**DEFENSE NUCLEAR FACILITIES
SAFETY BOARD**

November 1, 2013

Staff Issue Report

SUBJECT: Safety and Integrity Implications of Decanting Liquid from Hanford Tank 241-AY-102

Figure 2. Top—Hanford double-shell tank annulus (from RPP-ASMT-53793); Bottom—Secondary ventilation system air distribution for 241-AY-102 (from RPP-ASMT-53793).

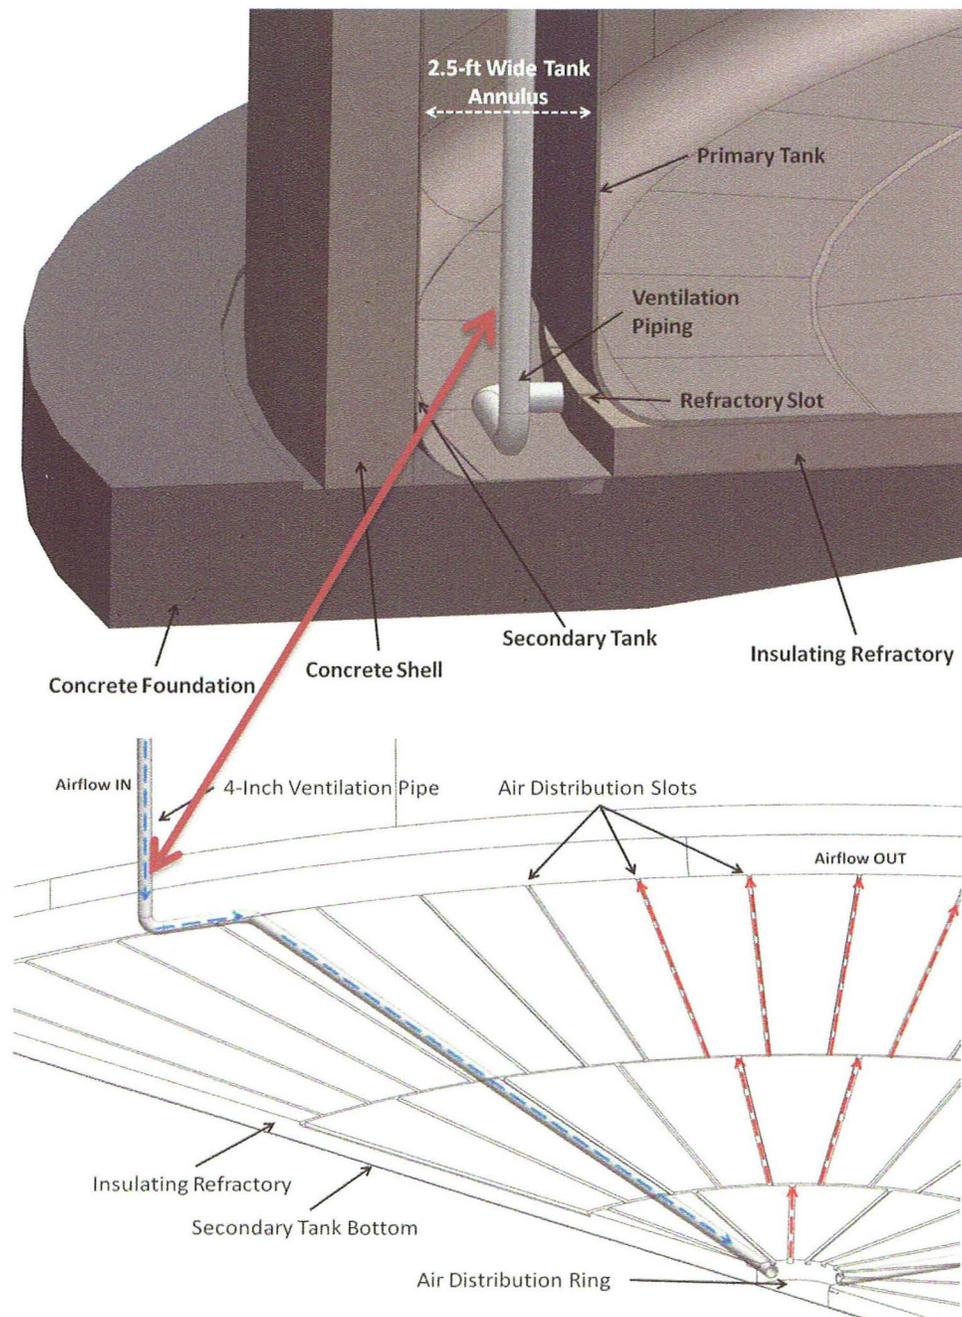
The complexity of the competing factors in this system is illustrated by liquid waste in the leak path to the tank annulus drying and forming solid deposits. For example, solid deposits can limit or plug the leak from the tank bottom. Conversely, because the leak path to the annulus is through the refractory slots, solid deposits can plug the air distribution system along the tank bottom (see Figure 4). Blockage of the refractory slots reduces air flow and limits the annulus ventilation air from cooling the tank bottom. Because the total volume of refractory slots is on

the order of several hundred gallons, a relatively small tank leak volume could significantly alter air flow in localized regions of the tank bottom. Any reduction of cooling would increase localized temperatures and thermal gradients on the tank bottom, potentially significantly increasing the corrosion rate.

Figure 5. Tank AY-102 refractory temperatures from a thermocouple 21 ft from the tank centerline when the primary ventilation system is on and the annulus ventilation is cycled on and off (source: Tank Waste Information Network System).

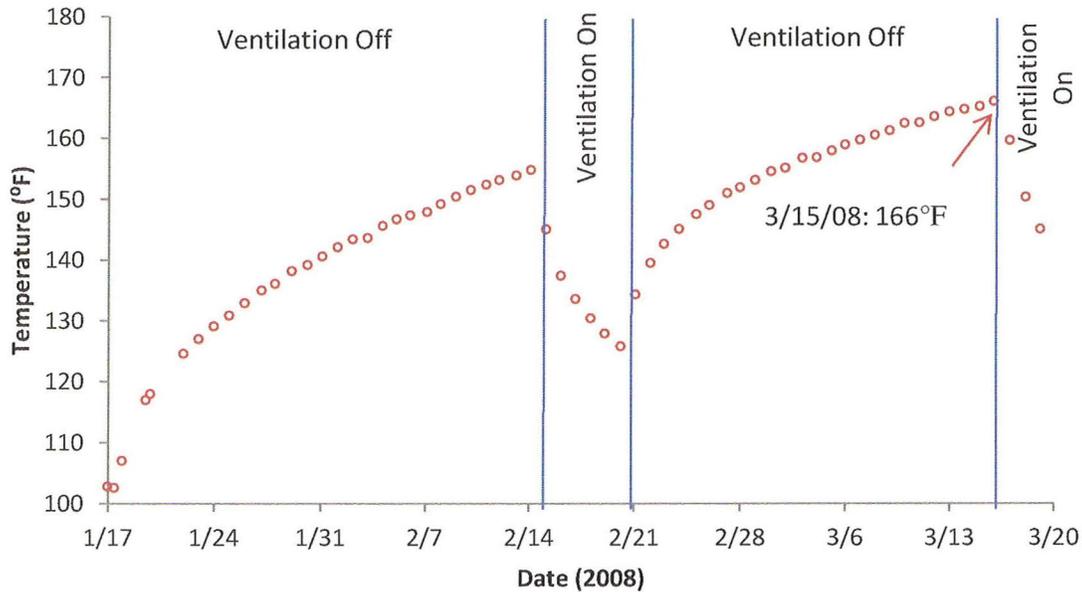
ventilation system. The staff members' analysis finds that temperatures on the tank bottom increase significantly when the annulus ventilation system is off. Figure 5 shows that the temperature of the refractory layer at the tank bottom increased steadily during a test when the primary ventilation system was on and the annulus ventilation system was cycled off. When the ventilation system was cycled on, the tank bottom was rapidly cooled.

After a decade of additional radioactive decay after retrieval from tank C-106 in the 1990s, on March 15, 2008, the temperature of the tank AY-102 refractory reached about 166°F and appeared to be steadily increasing until the annulus ventilation system was turned back on at the end of the test (see Figure 5). Based on these data, it is apparent that the historical C-106 maximum solids temperature range of 160 to 170°F does not represent an upper bound for tank AY-102. Because the half-life of the radioisotopes primarily responsible for the decay heat in the tank waste is about 30 years, 5 years for additional radioactive decay from 2008 to 2013 is not expected to significantly change this conclusion. These data show that a prolonged annulus ventilation outage will raise the temperature of the tank bottom, which may lead to increased hydrogen generation and corrosion rates. Higher localized tank temperatures can exist between tank thermocouple locations. The final tank temperatures cannot be accurately predicted or bounded with the existing WRPS analysis. A multi-dimensional, transient thermal transport model would be useful in assessing tank bottom temperature increases relative to corrosion control limits resulting from restricted air flow on the tank bottom.

Continued visual inspections of the tank annulus and close monitoring for variations in waste temperature (particularly near the tank bottom) and annulus ventilation, which can be indicative of increased leakage and blockage of the refractory slots that distribute cooling air to the tank bottom, are prudent steps if DOE proceeds with radioactive liquid decanting. Further analysis, including development of a more rigorous multi-dimensional, transient thermal transport model could provide better understanding of the significance of any observed changes.
